REPORT

File: PDP 16-01 AR 15-34

RE: Planned Development Permit 16-01 and Architectural Review 15-34 (Lava Ridge Apartments) – Vacant Lot Located at the Southeast Corner of Highway 32 and Bruce Road

ATTACHMENT C-1

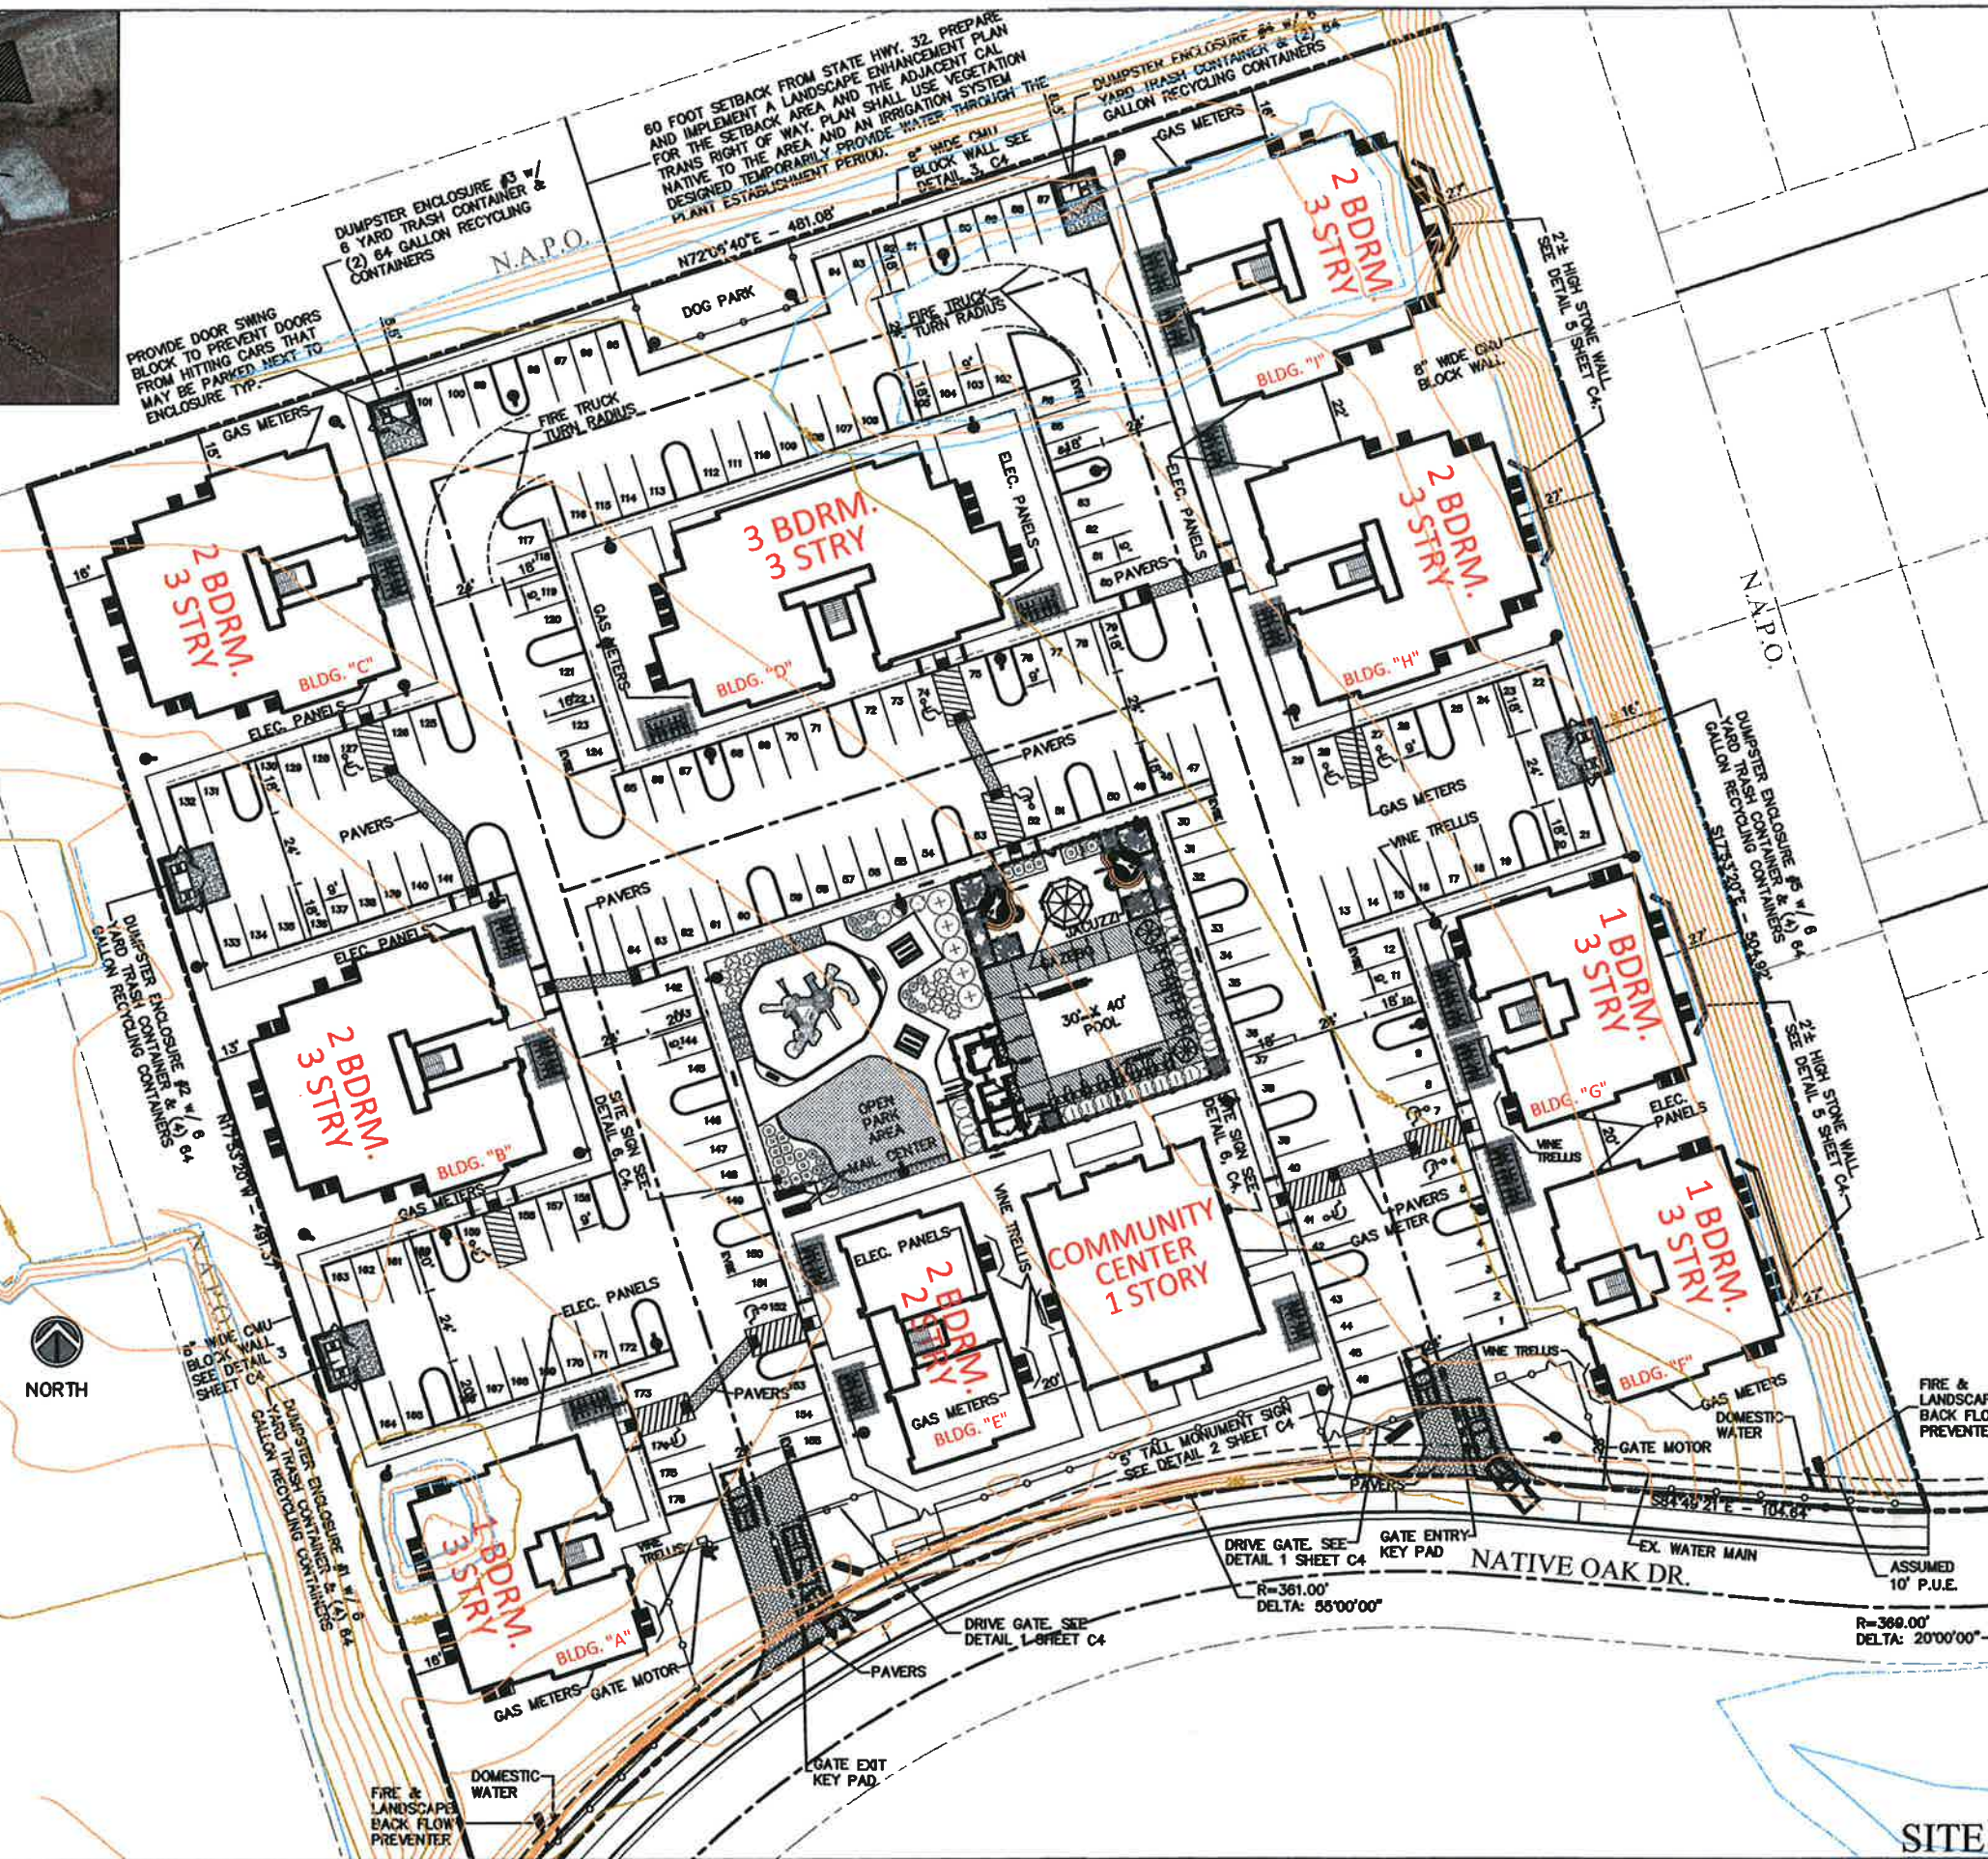
The applicant is proposing to develop the site with a 98-unit apartment complex creating a density of which at 19.7 units per acre (see Project Description, **Attachment B**). The site will be accessible by two driveways from the newly constructed Native Oak Drive to the south. The entrance driveways will be defined with pavers, which are also utilized to indicate the path of travel through the parking lot. Consistent with Design Guideline (DG) 4.1.33, which discusses texture changes to alert residence and adding visual interest. Staff notes, that the site plan does not indicate the type or style of pavers, therefore staff recommends that the Board discuss this detail with the applicant.

The site is designed in an "H" configuration and will have the community center, pool, Jacuzzi, play area and mailboxes centrally located, with the apartment structures around the perimeter (see Site Plan, **Attachment C1 and C2**). With tenant amenities centrally located, the project is meeting a design objective of creating an aesthetically pleasing and vibrant place to gather

The proposal does not include any deviations from Code standards, other than the request for an additional 10 feet as noted above. To ensure a greater quality or community benefit from conventional development, staff recommends that the Board discuss with the applicant angling the structures to provide additional interest and break up the static look of the site plan.

1. Discuss paver details that are noted on the site plan to be used for path of travel and at each vehicle entrance, and condition the project accordingly.
2. Discuss ensuring greater quality of project by angling proposed structures to add interest and break up the static look of the site plan, and condition the project accordingly.

2) MONUMENT SIGN DETAIL

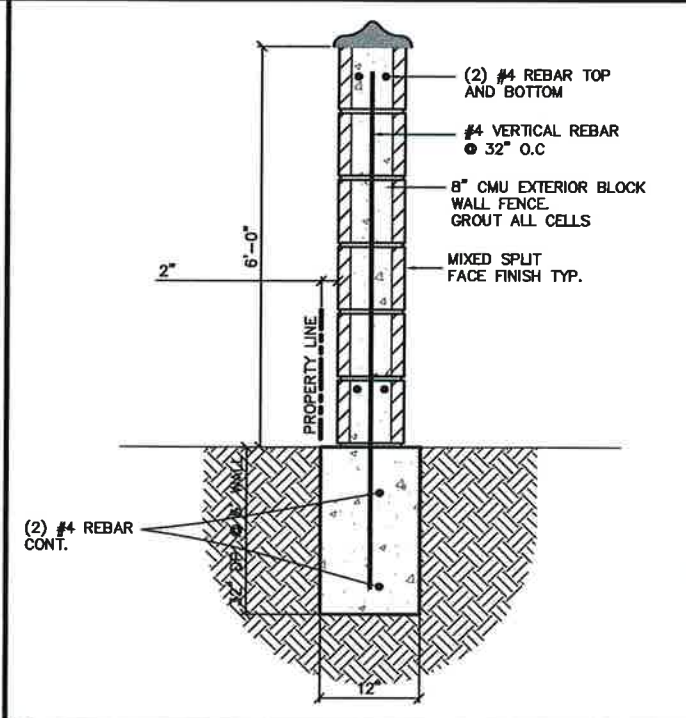
Signage is proposed near each entrance, and consists of structural elements and colors found in the project (DG 4.1.31), that will be illuminated with ground mounted lights. The monument sign meets both square footage and height requirements. However, Chico Municipal Code (CMC) 19.74 Signs – Table 5-8 permits one sign per street frontage, the project is proposing 2 and signage shall be indirectly illumination only. Therefore, staff has added a condition of approval that the proposed signage shall conform to CMC requirements prior to issuances of building permits.

3. Height of all structures is limited to 35 feet from finished grade.
4. Monument signage shall conform to Chico Municipal Code section 19.74 Table 5-8 prior to issuance of building permits.

4) BICYCLE RACK AND MOUNTING DETAIL

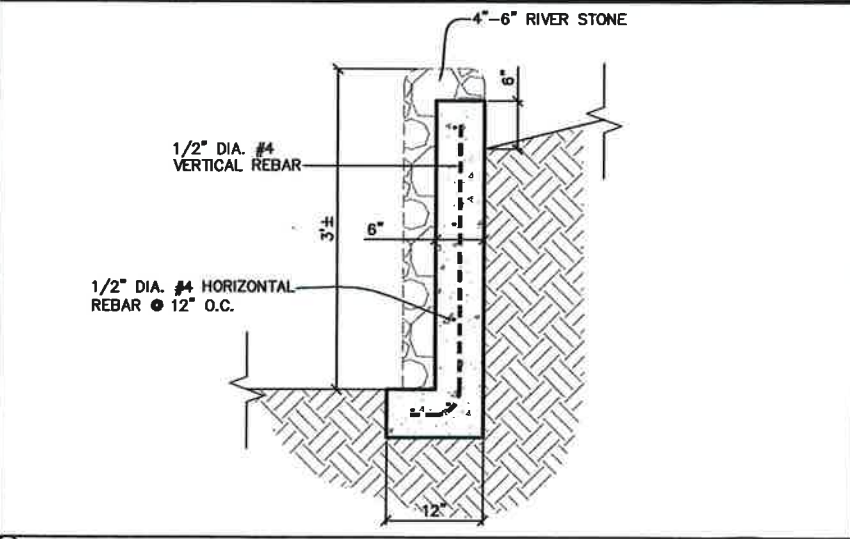
The project contains a total of 196 parking stalls, in compliance with code requirements. The stalls are placed throughout the site and accessible by two driveways from the street. The proposal meets DGs (DG 4.1.32) that discuss providing logical connections so that visitors can easily enter the site, park and find a particular unit. Bicycle parking is provided throughout the site and are covered. The bicycle stalls are the “S” design, which do not allow two points of contact for the bicycle frame. Therefore, staff recommends a condition of approval requiring the bicycle racks be of a design, such as an inverted “U”, that allows two points of contacts for bicycle frames.

5. Bicycle parking shall be of a design, such as an inverted "U" or similar, that allows two points of contact for the bicycle frame.
6. Parking lot lighting shall be limited to 10 to 12 feet in height from finished grade.

PHOTOMETRIC PLAN

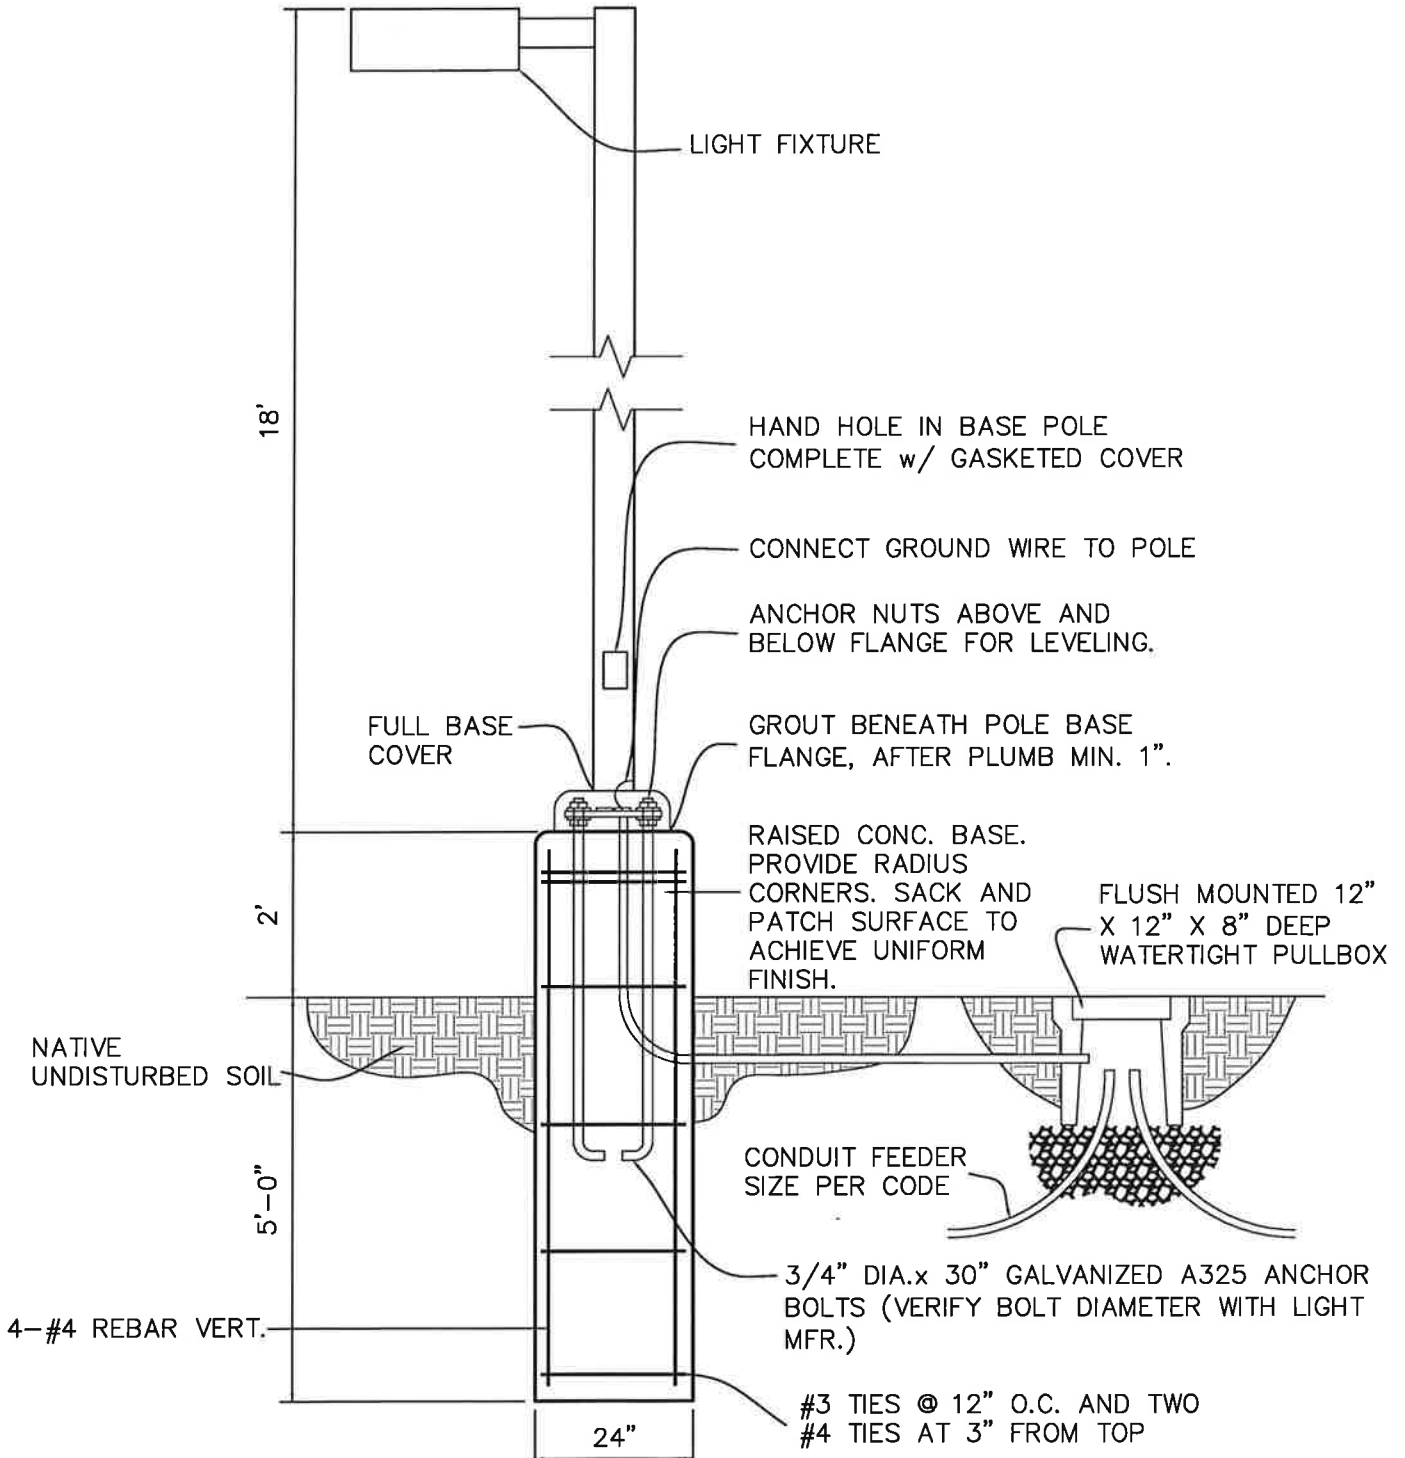
Lighting is noted on all structures to be LED wall pack, mounted at 7 feet. Parking lot lighting is noted at 18 feet on the photometric plan, while the light details notes 20 feet (see Photometric and Light Detail, **Attachment E**). Staff recommends lighting at a pedestrian scale, such as 10 or 12 feet, due to the setting, and have conditioned the project accordingly.
